Certificate of Appropriateness

Filing Date: October 24, 2024
Case Number: **24-43-HPC**
Request: **Certificate of Appropriateness**
Project Address: 500 Texas Street, Shreveport, LA 71101
Historic District: Downtown Shreveport Historic District
Zoning: D-1-CBD (Downtown Core Sub-District)
Applicant: **Mike Ferlito / Richard Greider**
MPC Review by: Walter Johnson, Community Planning Division
walter.johnson@shreveportla.gov
HPC Meeting Date: November 19, 2024

Exhibit D. Project Scope

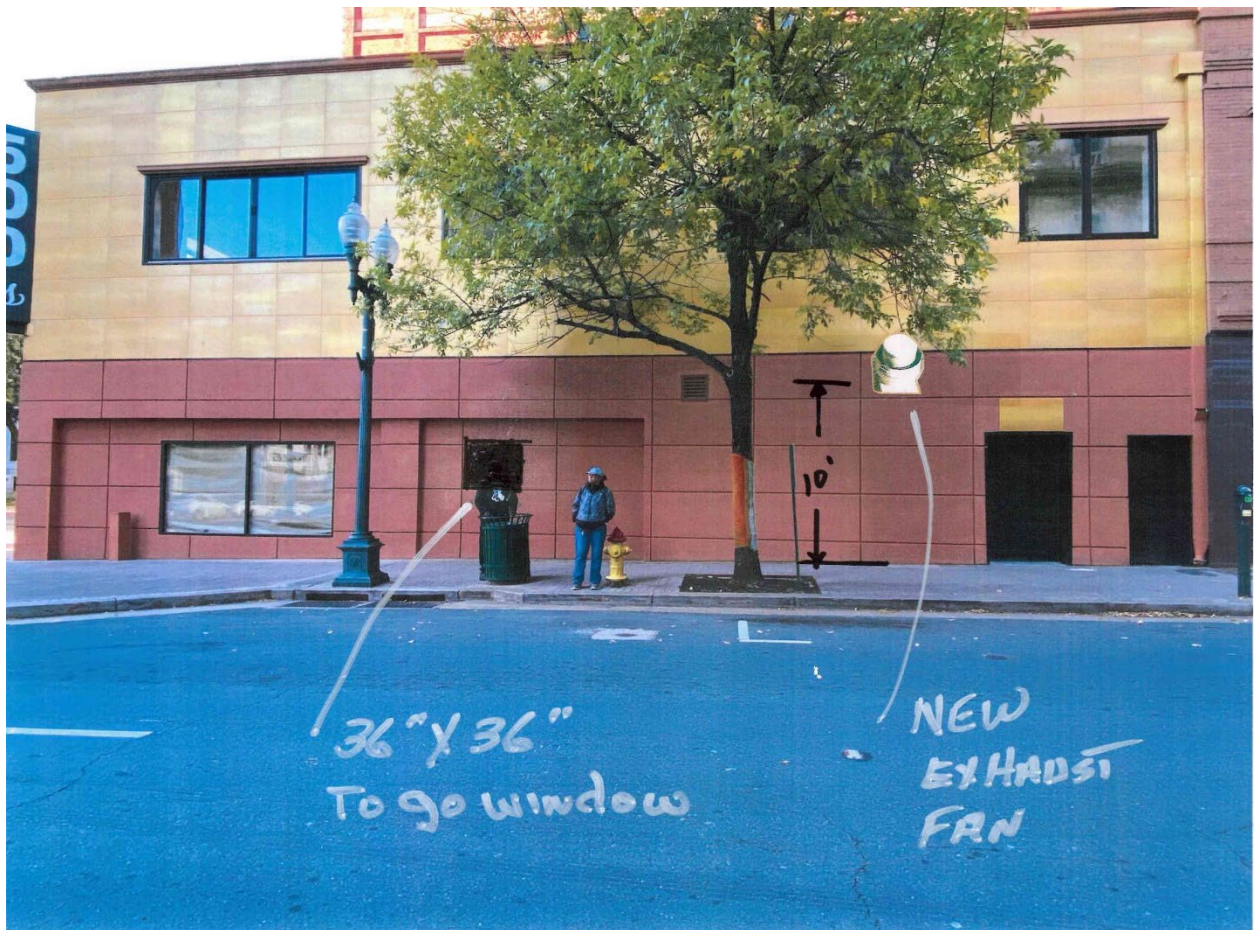
2. The proposed the installation of a commercial vent hood for cooking exhaust is not complaint with the City's building codes. Per an email received on Friday, November 15 by Mike Sepulvado, the Chief Building Official, "The vent hood will not be able come out on the side of the building over a walking surface, per the 2021 International Mechanical code adopted by the Louisiana code council. We have no issues with the service window."

2. Prior to issuance of a building permit, the applicant submits a revised COA application that only shows the installation of the 36" x 36" serving window on the Marshall Street side. The vent hood, as indicated on the current application, cannot be located at its current location shown. *(The Applicant will need to get with Permits and Inspections as to how, and where, the vent hood can be placed. Per the 2021 International Mechanical Code, adopted by the Louisiana Code Council, 2023, a vent hood cannot extend over a walking surface, which in this case would be the sidewalk along the Marshall Street right-of-way. Consequently, the vent hood would need to be re-routed to extend vertically above the roof, terminating at no less than 40 inches from the roof surface or alternatively the vent hood would need to run to the side alley on the north face of the building to terminate.)*
